100/300 AREA UNIT MANAGER MEETING ATTENDANCE AND DISTRIBUTION

100 & 300 AREA UNIT MANAGER MEETING MINUTES

Groundwater and Source Operable Units; Facility Deactivation, Decontamination, Decommission, and Demolition (D4); Interim Safe Storage (ISS); Field Remediation (FR); Mission Completion; and 100-K Sludge Treatment Project and 100-K Facility Demolition and Soil Remediation projects

January 10, 2013

Distances between Sample Plan Coordinates and Actual Sample Coordinates

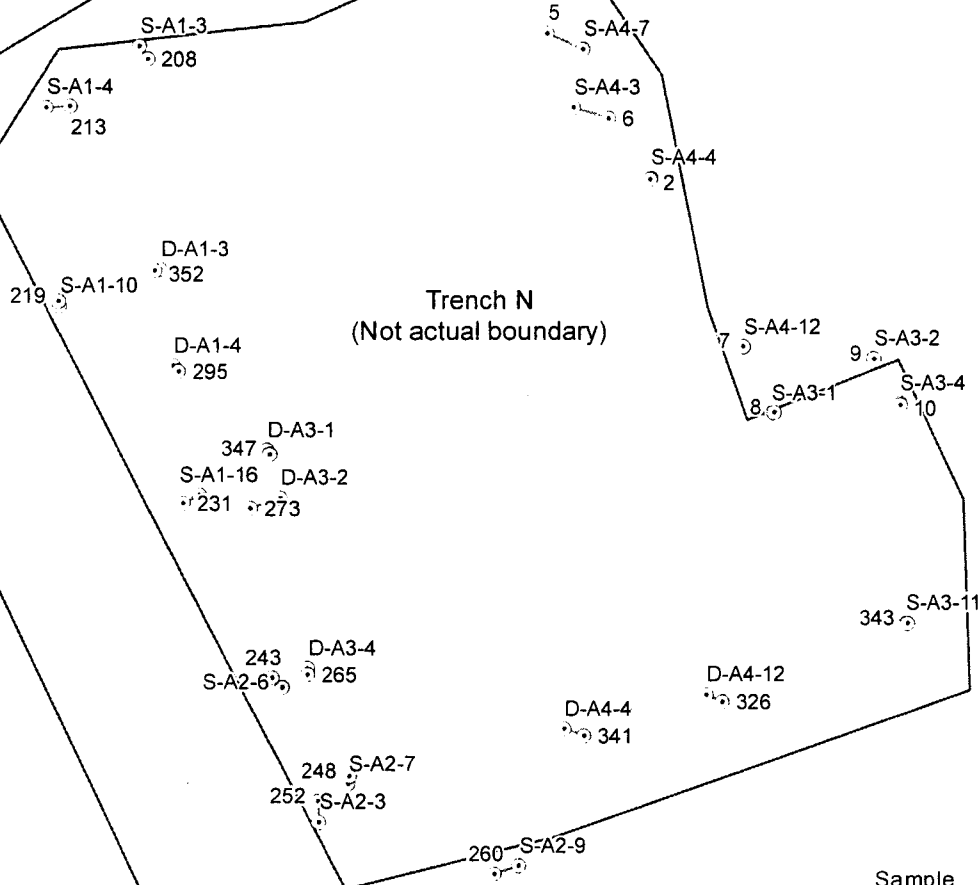
- (1) if a position is not listed on the figure it is because we were able to collect it by hand at the planned location.
- (2) the two greatest "deltas" come for the locations that fell out on the ramp that had to be moved (S-A4-7, and S-A4-3).
- (3) otherwise, only one delta was greater than 2 meters, and the majority were less than 1 meter.

Jason stopped by my office as well. I also concur with the revised sample locations.

samples. I concur with the revised sample locations and the justification for the relocation.

Subject: RECONTOURING OF 100-N-33

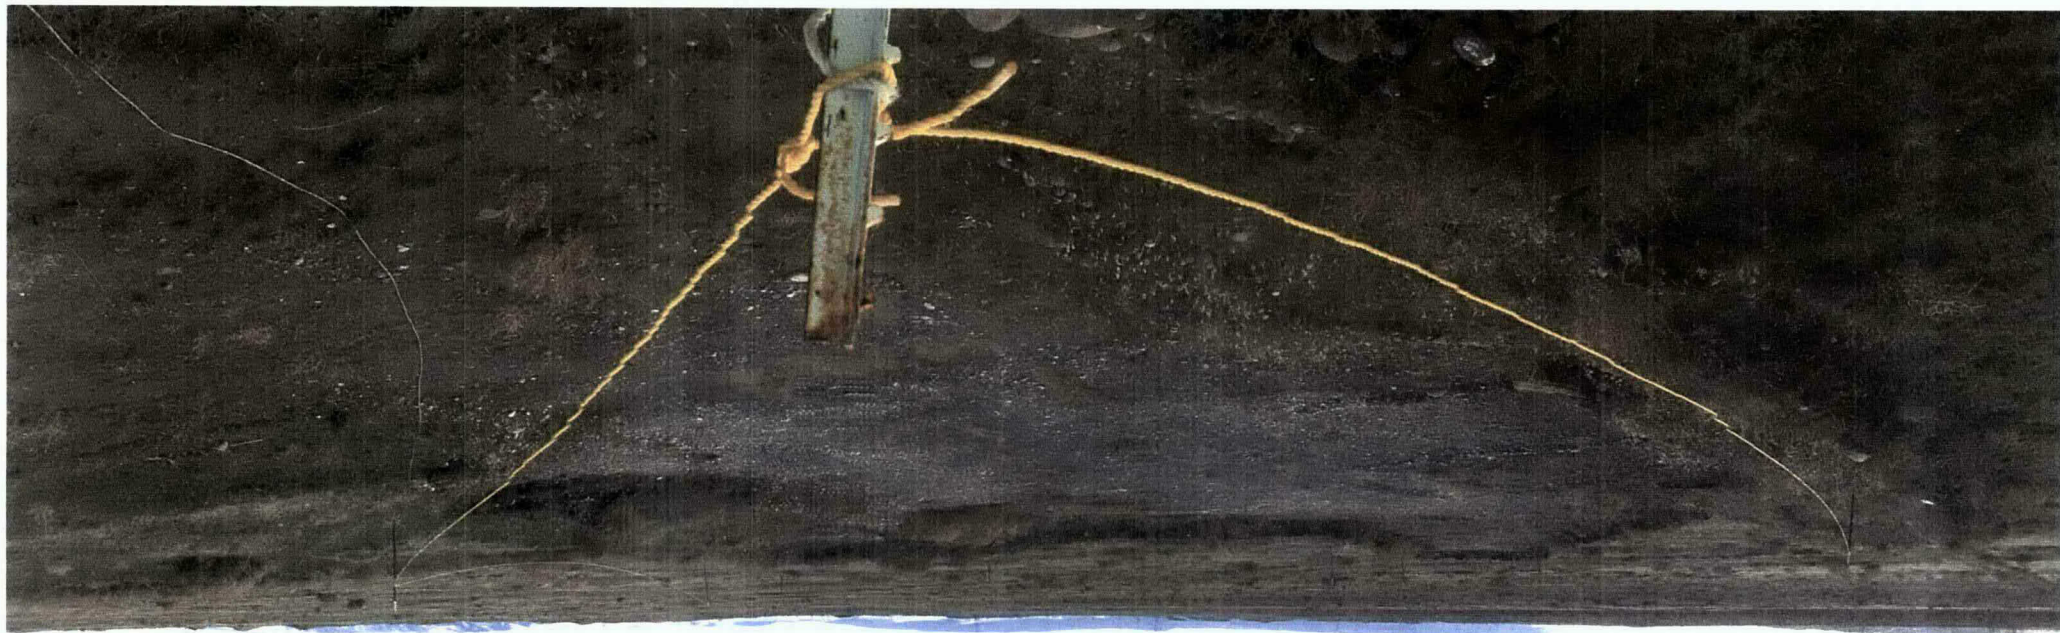
Wanda/Joanne, 100-N-33 was recently closed out and is ready for backfill/revegetation. Since the deepest portion of the excavation was only approximately 2', we'd like to propose just smoothing the edges of the excavation to blend it in with the surrounding terrain. See attached photo and let me know what you think? We've got the contractor out there now, so if you could let me know soon, I'd appreciate it.

Thanks for the clarification. The recontouring plan sounds fine to me, too.

Figure 1. 116-N-2 Waste Site Additional Remediation Sketch.

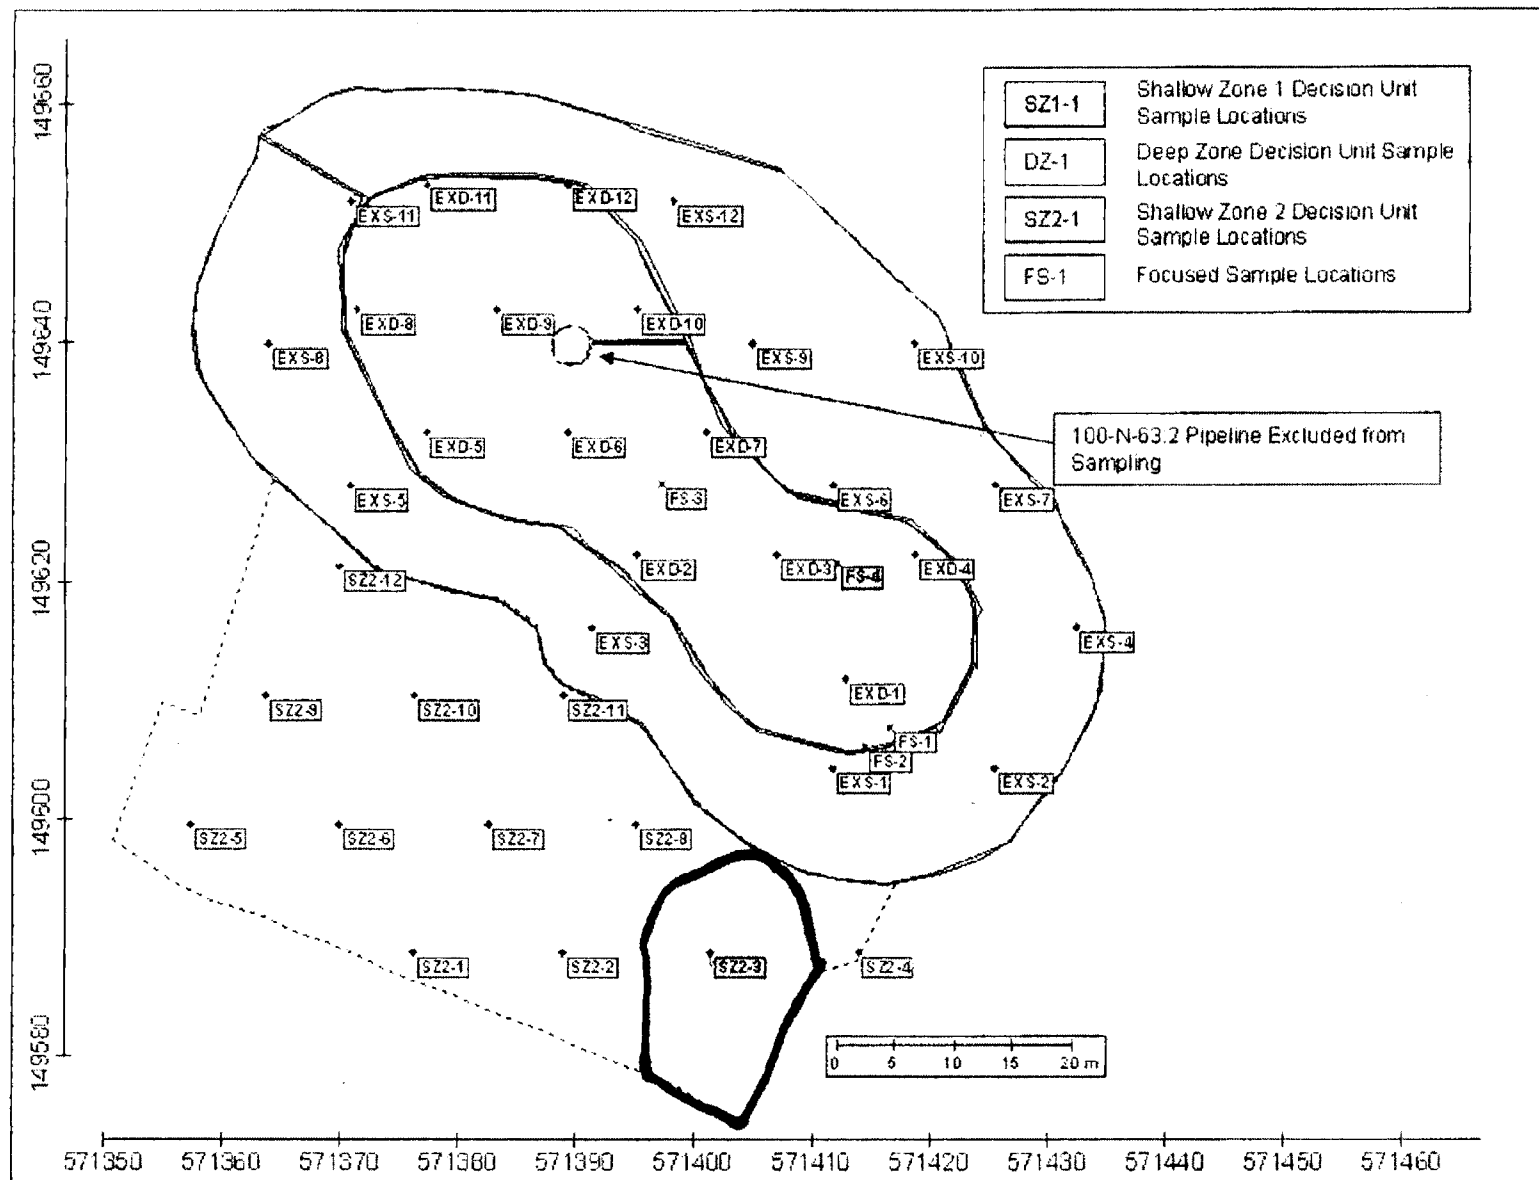
Washington Closure Hanford proposes additional soil to be removed from the 116-N-2 waste site excavation at the SZ2-3 location for disposal at the Environmental Restoration Disposal Facility. To be conservative, generally, half the distance between the failed verification sample location and the nearest passing verification sample location is used as the boundary for additional soil removal (Figure 1). The depth of additional soil removal will be between 1 to 2 meters depending on observations in the field (e.g., discolored or stained soil, debris, etc.).

Following additional soil removal, replacement samples will be collected at SZ2-3. The replacement samples will be analyzed for the failing analyte(s) only. A summary of replacement samples, including sample location and requested analyses, is provided in Table 1.

Figure 1. 100-N-60 Group Additional Remediation Sketch.

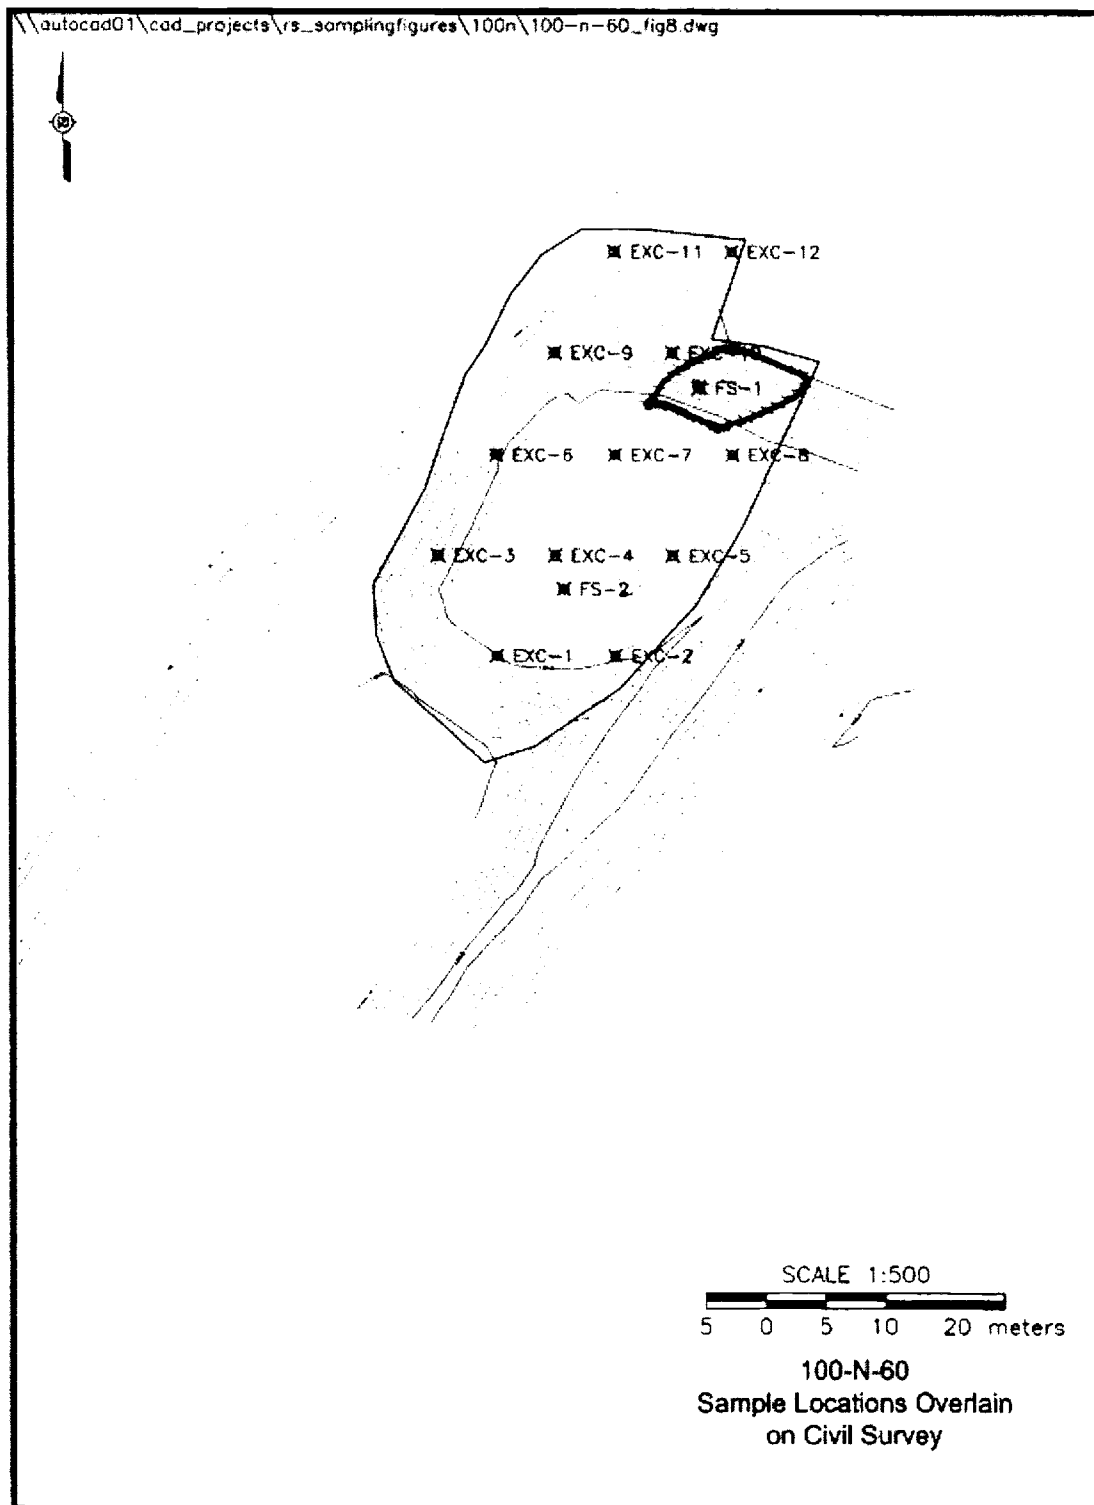
Washington Closure Hanford proposes additional soil to be removed from the 100-N-60 grouping of waste sites excavation at FS-1 location for disposal at the Environmental Restoration Disposal Facility. To be conservative, generally, half the distance between the failed verification sample location and the nearest passing verification sample location is used as the boundary for additional soil removal (Figure 1). The depth of additional soil removal will be between 1 to 2 meters depending on observations in the field (e.g., discolored or stained soil, debris, etc.).

Figure 1. 100-N-63:2 Approximate Remediation Area Sketch.

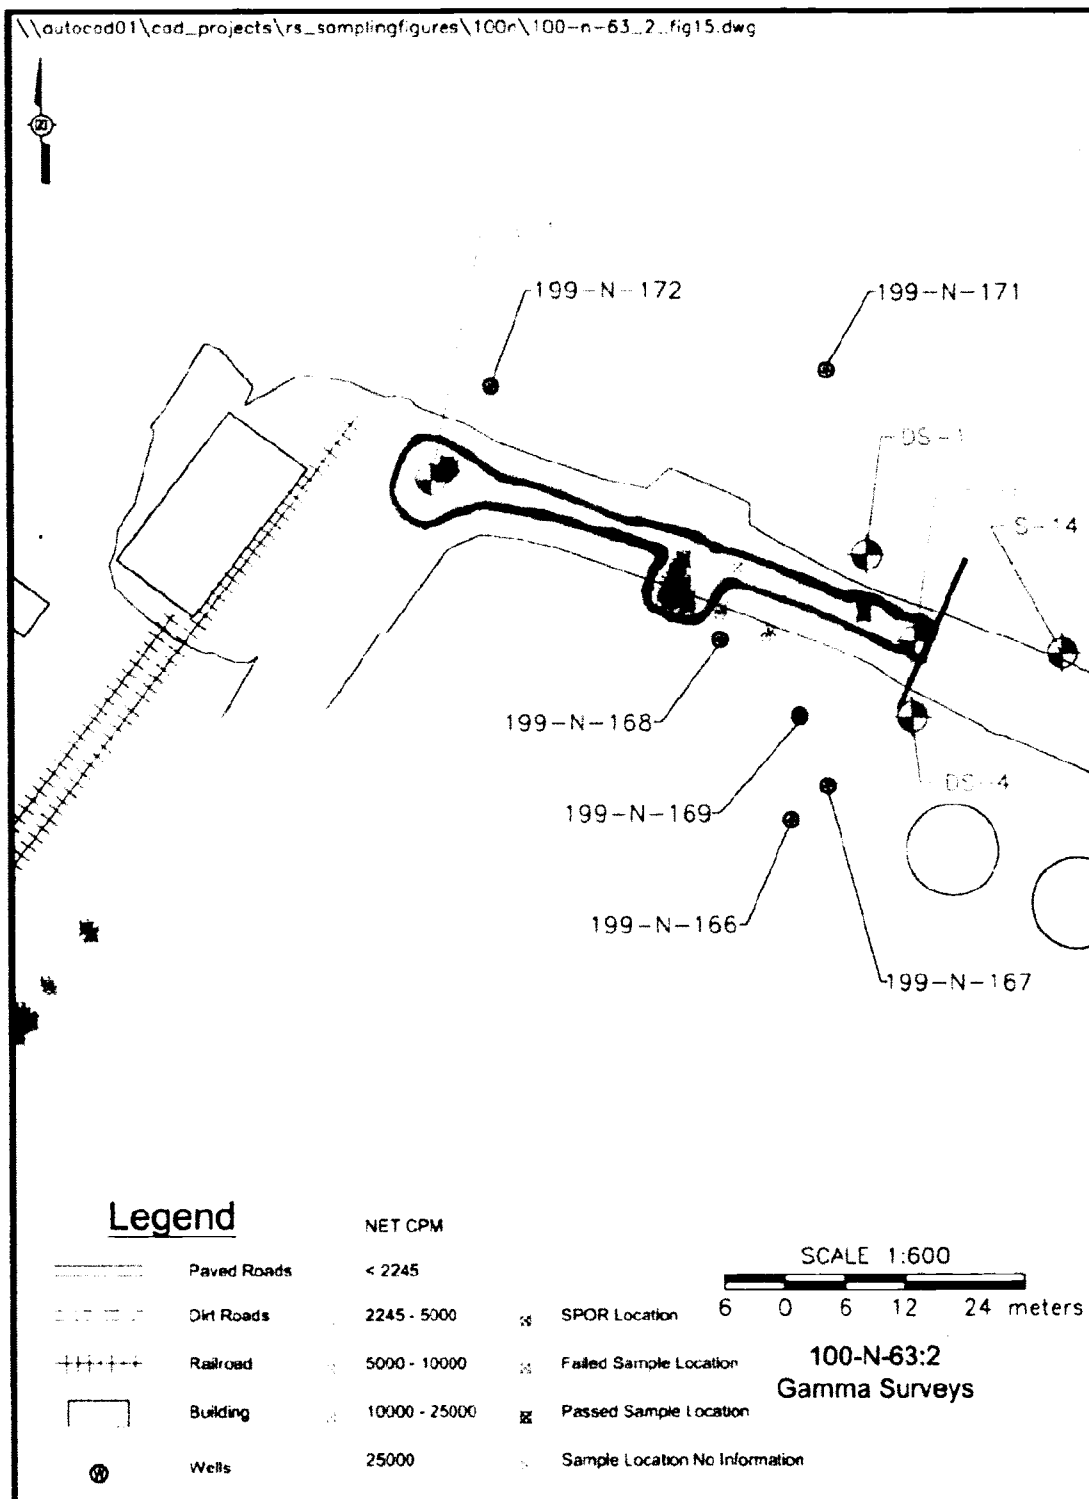
Washington Closure Hanford proposes additional soil to be removed from the 100-N-63:2 subsite excavation within the areas of S-1 and S-15 locations for disposal at the Environmental Restoration Disposal Facility (Figure 1). GEPRS surveys will be used to guide field excavations and focus on areas where contamination is most probable. The depth of additional soil removal will be between 0.5 to 2 meters depending on observations in the field (e.g., discolored or stained soil, debris, etc.), GPERS surveys, and well interferences.

Figure 1. 100-N-6, 100-N-16, 100-N-98 and 128-N-1 Additional Remediation Sketch.

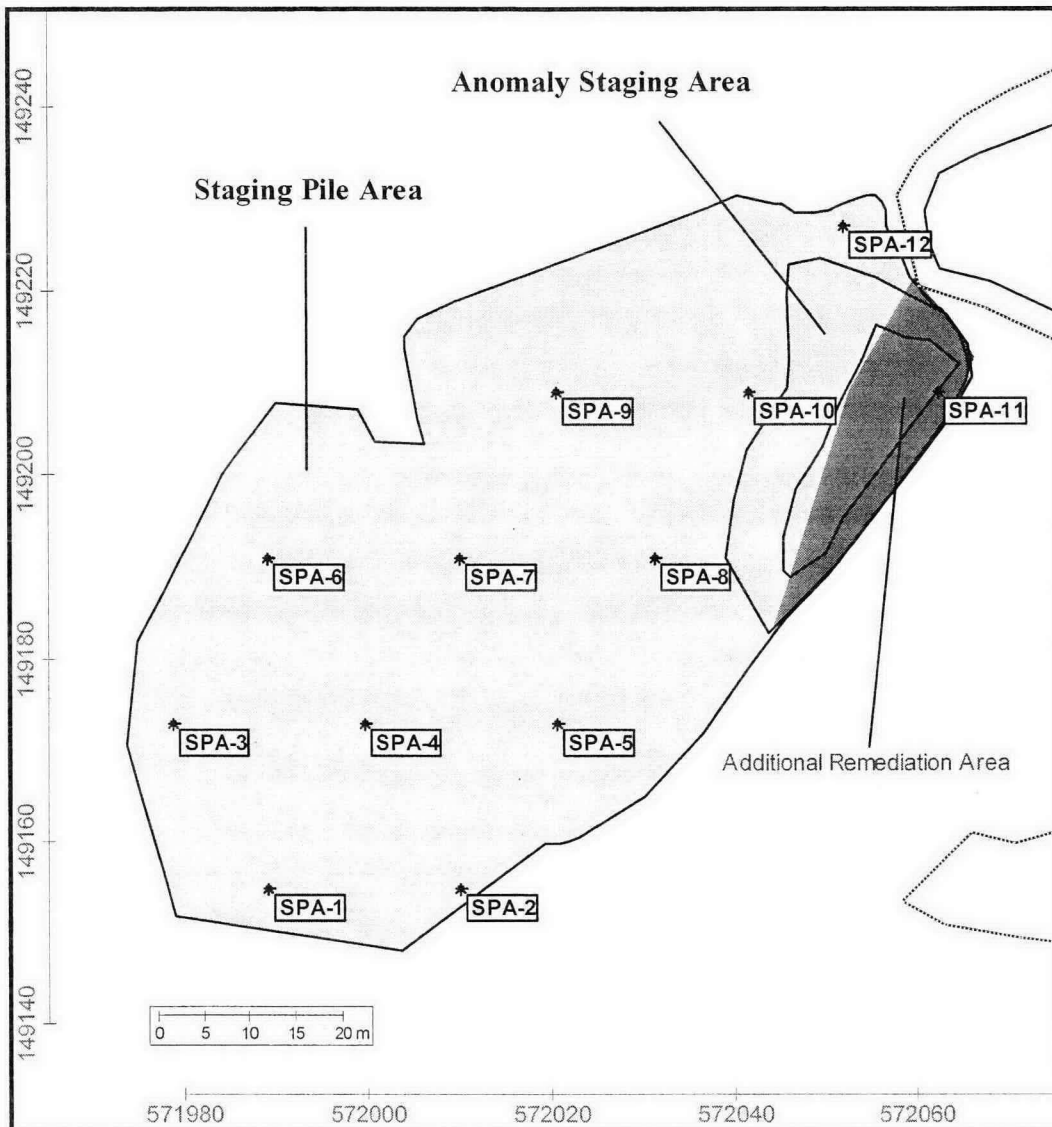
Washington Closure Hanford proposes additional soil to be removed from the 100-N-6, 100-N-16, 100-N-98 and 128-N-1 waste sites staging pile area at the SPA-11 location for disposal at the Environmental Restoration Disposal Facility. To be conservative, generally, half the distance between the failed verification sample location and the nearest passing verification sample location is used as the boundary for additional soil removal (Figure 1). The depth of additional soil removal will be between 1 to 2 meters depending on observations in the field (e.g., discolored or stained soil, debris, etc.).

Figure 1. 100-N-87, UPR-100-N-9, UPR-100-N-14 and 100-N-102:1 Additional Remediation Sketch.

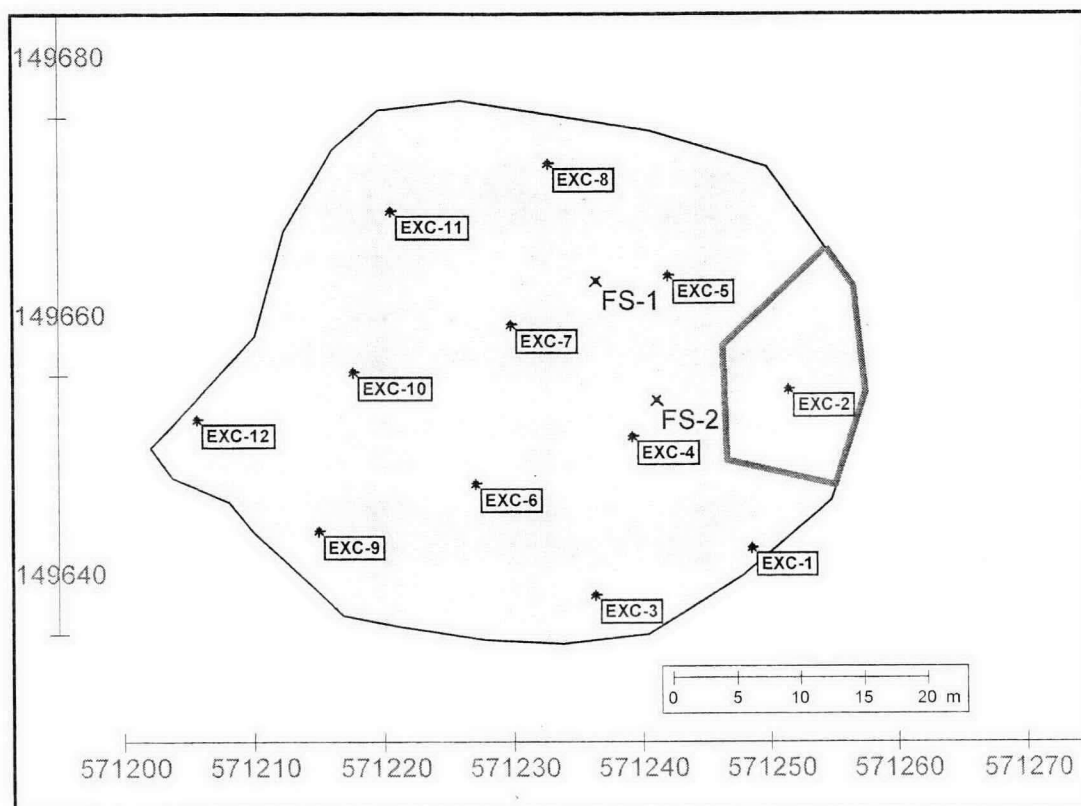
Washington Closure Hanford proposes additional soil to be removed from the 100-N-87, UPR-100-N-9, UPR-100-N-14 and 100-N-102:1 waste sites excavation at the EXC-2 location for disposal at the Environmental Restoration Disposal Facility. To be conservative, generally, half the distance between the failed verification sample location and the nearest passing verification sample location is used as the boundary for additional soil removal (Figure 1). The depth of additional soil removal will be between 1 to 2 meters depending on observations in the field (e.g., discolored or stained soil, debris, etc.).

The plan is acceptable to me also.
